Appendix I of RNTPC Paper No. A/YL-PH/1036

# UNDER SECTION 16 OF THE TOWN PLANNING ORDINANCE

劃資料查詢處供一般參閱。)
Application No. 申請編號	(For Official Use Only) (請勿填寫此欄)
Location/address 位置/地址	新界元朗八鄉七星崗DD110 LOT NO. 247(部份), 249, 250(部份), 251S.A RP(部份), 251S.B(部份), 262(部份), 263S.A&S.B&S.C(部份), 264(部份), 265, 266(部份), 267(部份), 269(部份), 269(部份), 270S.E(部份), 272, 273S.A, 273S.B, 274, 275, 276RP(部份), 277, 278, 279S.A, 279S.B, , 280, 281(部份), 285, 286, 287, 295, 299
Site area 地盤面積	30211 sq. m 平方米口 About 約
	(includes Government land of 包括政府土地 N/A sq. m 平方米 □ About 約)
Plan 圖則	S/YL-PH/11
Zoning 地帶	農業
Type of Application 申請類別	<ul> <li>✓ Temporary Use/Development in Rural Areas or Regulated Areas for a Period of 位於鄉郊地區或受規管地區的臨時用途/發展為期</li> <li>✓Year(s) 年3 □ Month(s) 月</li> <li>□ Renewal of Planning Approval for Temporary Use/Development in Rural Areas or Regulated Areas for a Period of 位於鄉郊地區或受規管地區臨時用途/發展的規劃許可續期為期</li> </ul>
	□ Year(s) 年 □ Month(s) 月
Applied use/ development 申請用途/發展	擬議臨時貨倉(危險品倉庫除外)及露天存放建築機械和建築材 料連附屬設施(為期3年)及相關填土工程

#### **Response to Comment**

Planting Buffer Area (min. 2m wide) at majority portion of the Site boundary for Retention of Existing Trees and Provision of New Trees to create a Soft-planted Edges along Site Boundary and to blend in with the adjacent Natural Context.

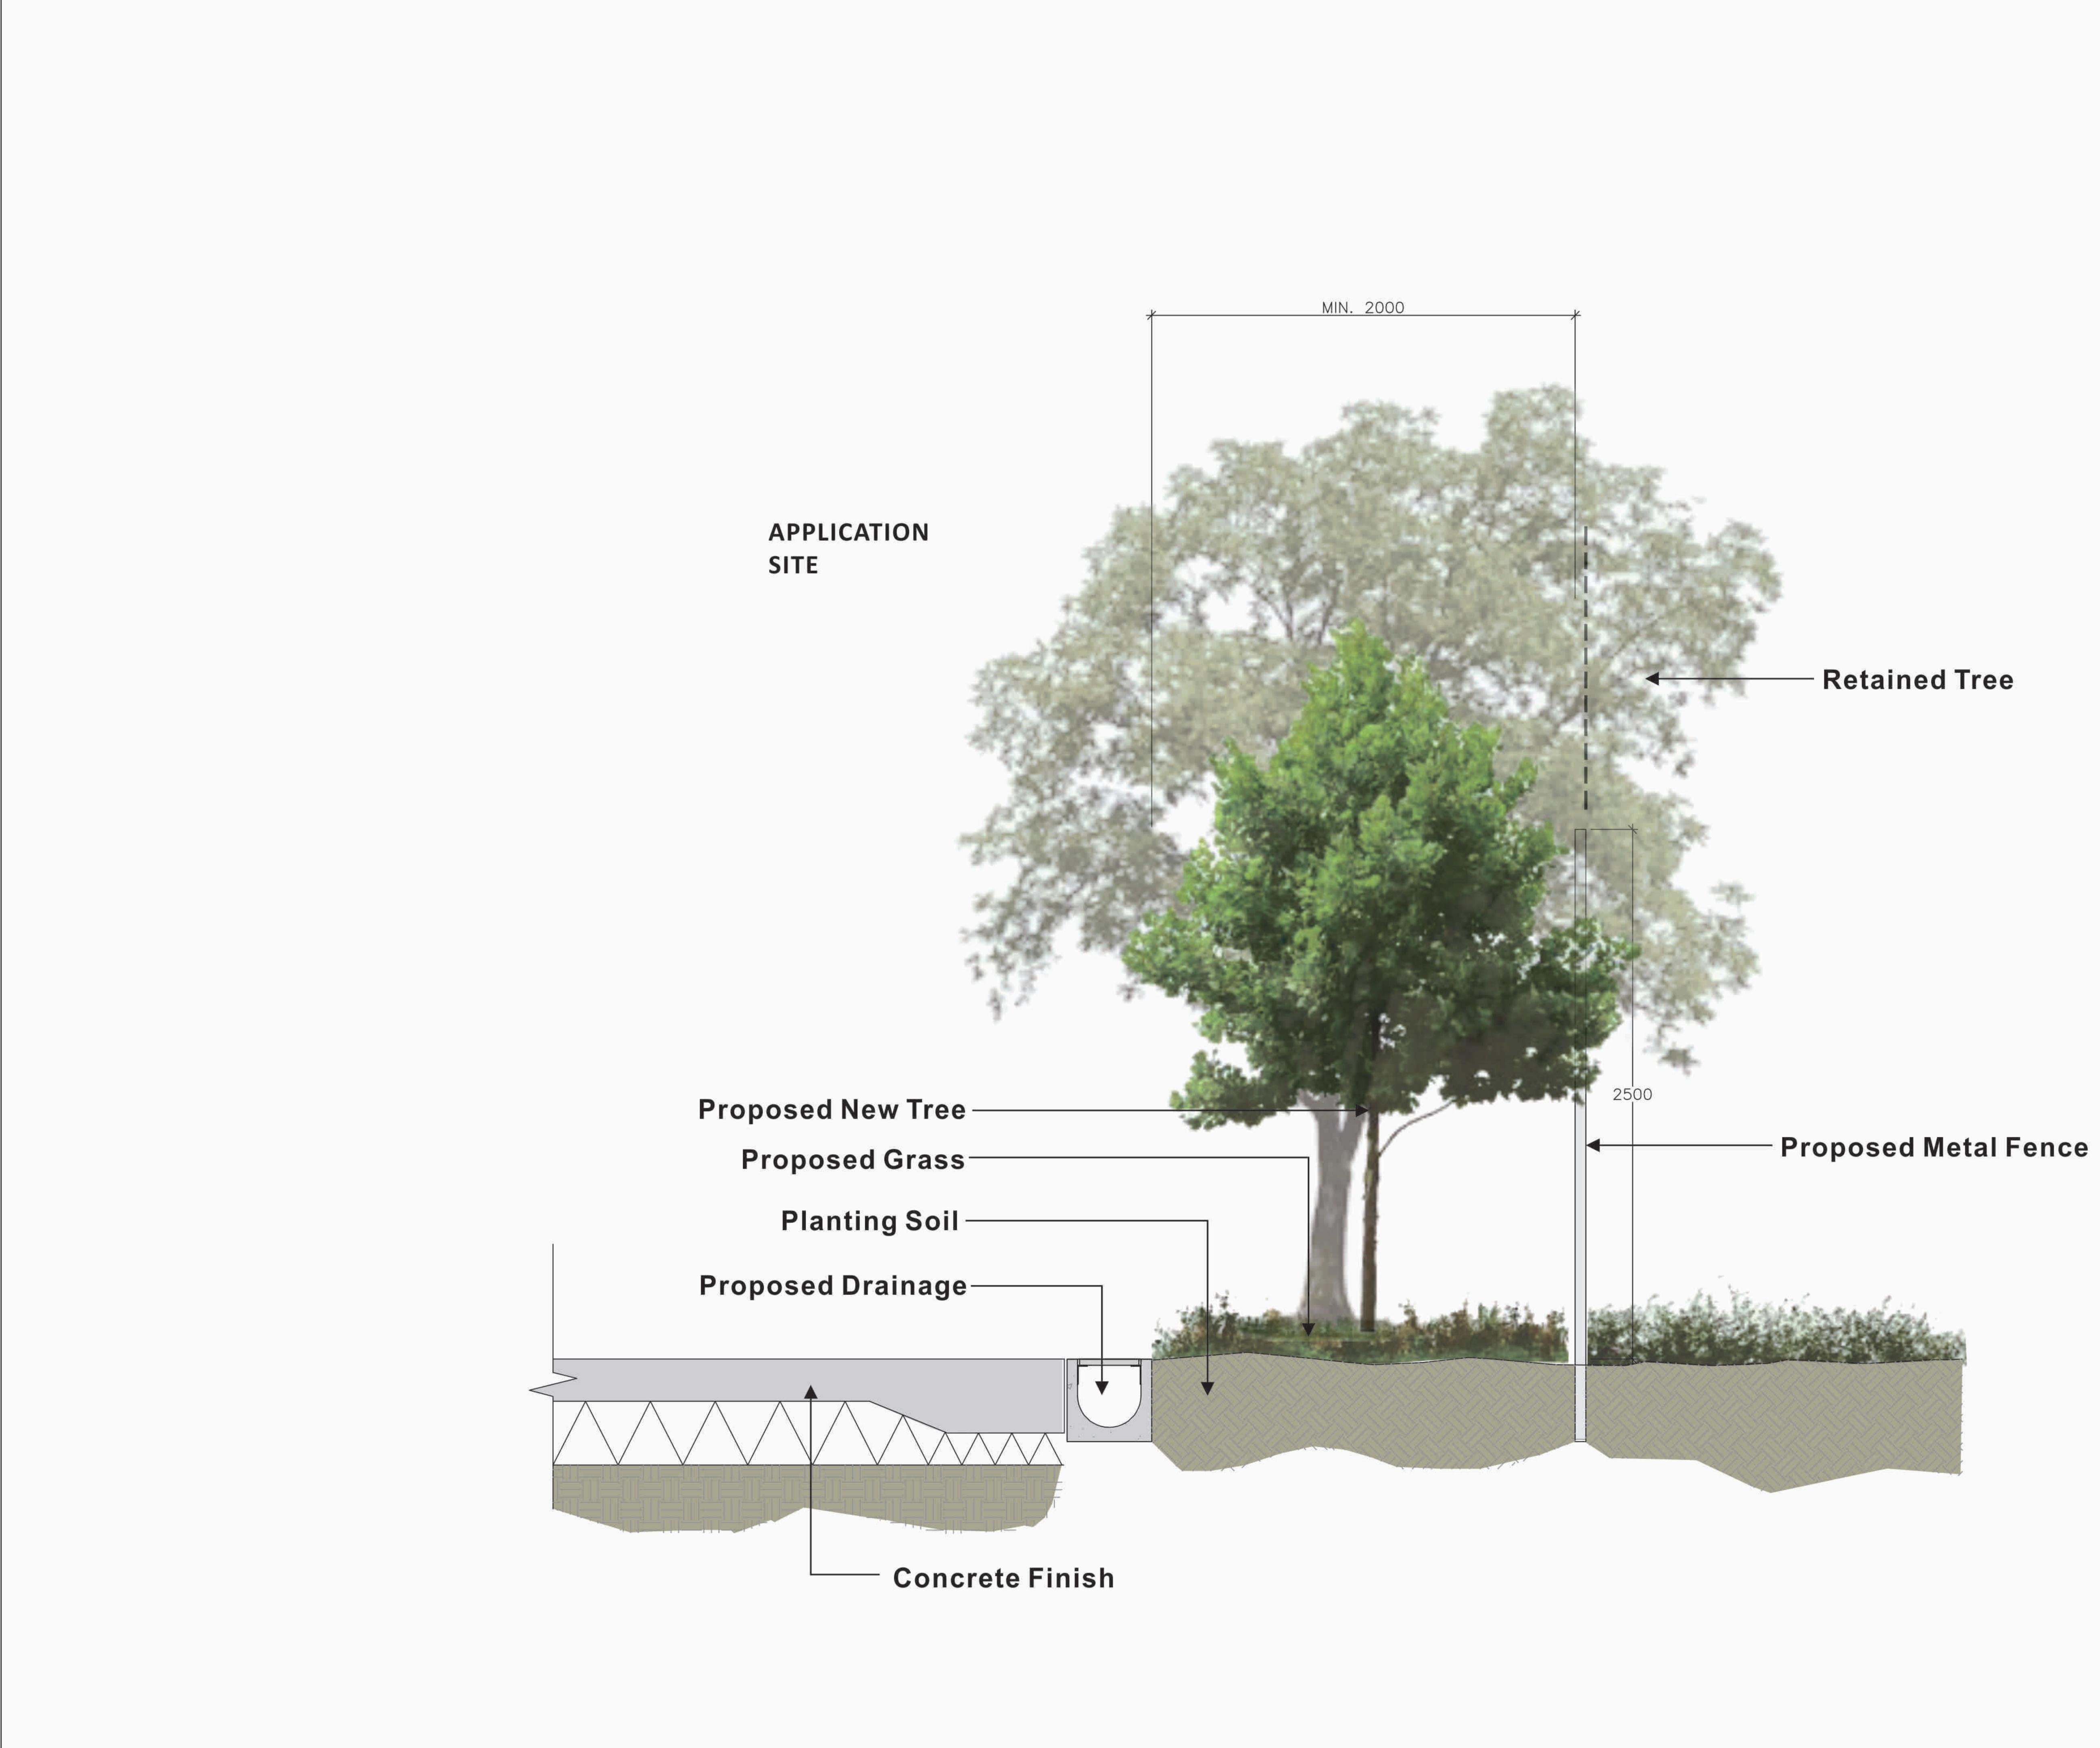
/ New tree planting	(N.B. paras 5.1.4 and 6.4 of the TPLP stated that 40 trees are proposed.)	
Re Drawing No. CP01, the applicant is advised to plant new trees at vacant areas along the east boundary of the Site (i.e. between proposed storage areas and metal fence) to enhance the greenery.		Noted. Additional trees are proposed at vacant areas along the east boundary, as shown on dwg. no. <b>CP01</b> .
3) The applicant is advised that approval of the application does not imply approval of tree works, if any, such as pruning, transplanting and felling. Application for any tree works should be submitted direct to relevant authorities) for approval.		Noted.
